Access Compliance Report

Public Rights-of-Way

Intersection ID: N/A	Main Street: DOGGETT_ST	Cross Street: N/A	Location: SW
ADA ID: 380C350A5E53	Ramp Type: PerpDiag	Initial Pass/Fail: Fail	Overall Compliance: No
Codes/Mitigation Info/Possible Solution		Field Measurements/Component Compliance	
Severity Score: 21.25

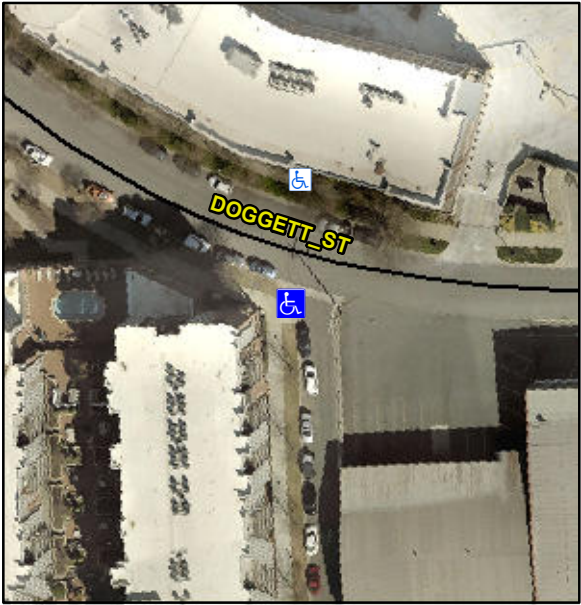
Possible Solutions:	Compliance	Description	Data	Compliance	Description	Data
	Remove & Replace Curb Ramp With Two New Directional Ramps or Equivalent.	N/A	Ramp Length (in)	89.0	No	Ramp Slope (%)	9.6
Surveyor Notes: N/A PROW/ADA: R304.5.1, R304.2.2		No	Ramp Width (in)	46.0	Yes	Ramp XSlope (%)	1.3
		N/A	Flare Type LT	N/A	N/A	Flare Type RT	N/A
		N/A	Flare Slope LT (%)	N/A	N/A	Flare Slope RT (%)	N/A
		N/A	Flare Traversable LT?	N/A	N/A	Flare Traversable RT?	N/A
		N/A	Landing Length (in)	N/A	N/A	DWS Provided?	N/A
		N/A	Landing Width (in)	N/A	N/A	DWS Contrast?	N/A
		N/A	Landing Slope (%)	N/A	N/A	DWS Length (in)	N/A
		N/A	Landing X Slope (%)	N/A	N/A	DWS Full Width?	N/A
		N/A	Landing Curb? (Y/N)	N/A	N/A	DWS Offset (in)	N/A
		N/A	Shared Landing?	N/A			
		N/A	Gutter Ponding?	N/A	N/A	Gutter Slope (%)	N/A
		N/A	Gutter Lip Ht (in)	N/A	N/A	Gutter X Slope (%)	N/A
		N/A	Painted X Walk1?	No	N/A	Painted X Walk2?	No
			X Walk 1 Direction	To E		X Walk 2 Direction	To N

N/A	X Walk 1 Width (in)	N/A	N/A	X Walk 2 Width (in)	N/A
			X Walk 1 Slope (%)	8.2		X Walk 2 Slope (%)	12.3
			X Walk 1 X Slope (%)	6.2		X Walk 2 X Slope (%)	7.9
		N/A	Ramp inside XWalk1?	N/A	N/A	Ramp inside XWalk2?	N/A
			Road Slope (%)	3.5	N/A	Clear Space?	N/A
			Road X Slope (%)	10.2	N/A	Clear Space to XWalk (in)	N/A
		N/A	Any Obstructions?	N/A	N/A	Storm Grate/Utility Hazard?	N/A
			Obstruction Type			Storm Grate/Utility Type	
				N/A			N/A
					Yes	Surface Condition? (G/P)	Good
